Quality Control Check Report. Stage: After Finishing Stage II (Apartments)

GULMOHAR RESIDENCY

Sy. No. 19, Mallapur Village, Uppal, Hyderabad.
Owned & Developed by: M/s. Modi Realty Mallapur LLP.
Head office: 5-4-187/3&4 M G Road Secunderabad.

Flat No	H - 104	Block no.	H.
Flat Area	sft	Type	Deluxe / Luxury
Buyer Name	Mr. P. Lavanya		
Phone No.	7036053694	Email	lavanya.virginia@gmail.com.

Wall breacking as per drawing.

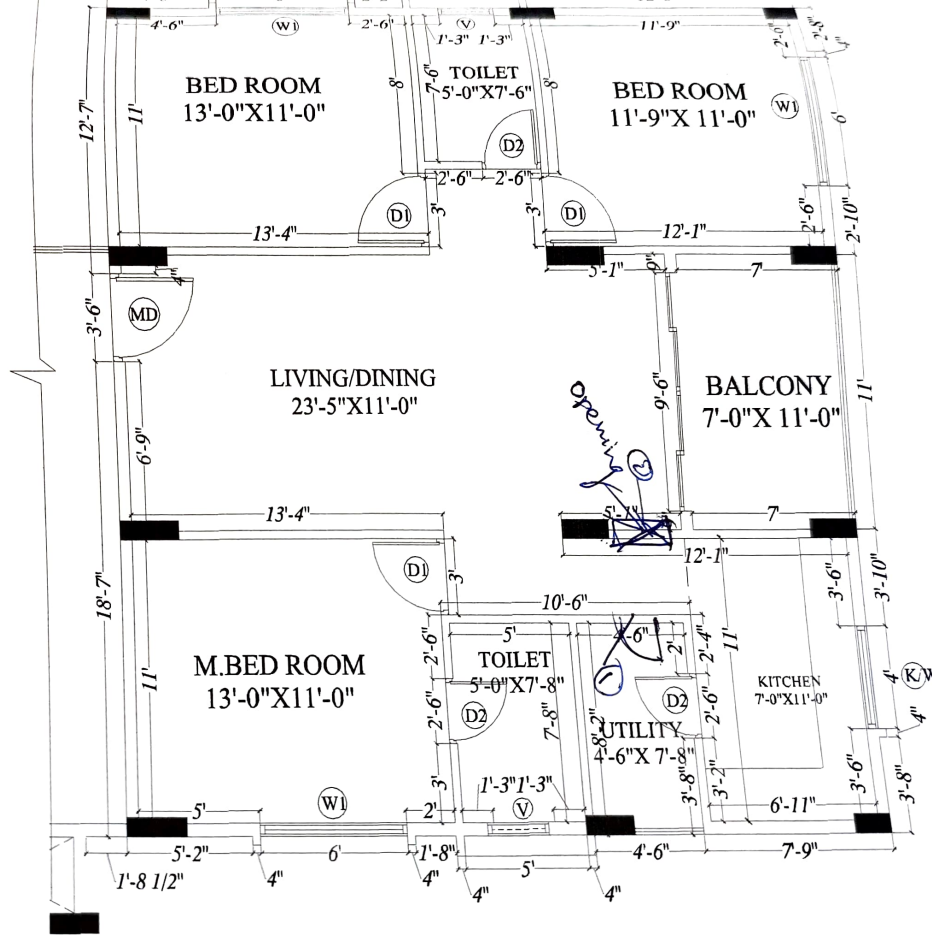
Changes in flooring:

- ✓ 1) Natural wood, ^{dark} tiles in MRIP & RR (East side room)
- 2) Vitrified tiles — Guest bed room.
- ✓ 3) Ultra Spine — 2 toilets.
- 4) ~~White~~ bed room kitchen ~~vitrified~~
- 5) Hall — canite beige & kitchen
- 6) Balcony — Country Rose.
- 7) Utility — Black & white.
